**Shenzhen DO Intelligent Technology Co., Ltd**

Ref: FCC Class II Permissive change for FCC ID:2AHFT841

This is to request a Class II Permissive change for FCC ID: 2AHFT841 originally granted on 2024-01-04 (date).

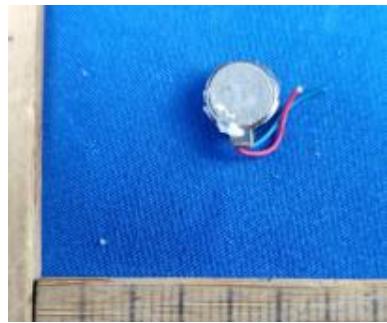
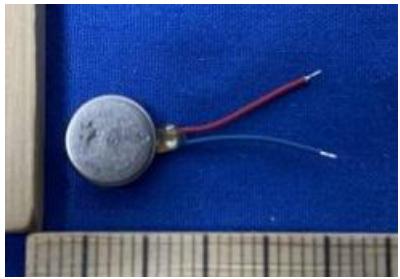
1. The screen model, motor model, appearance is different including having different supplier. The key differences are the appearance and the model number.

IDW19

IDW26-Z, IDW13
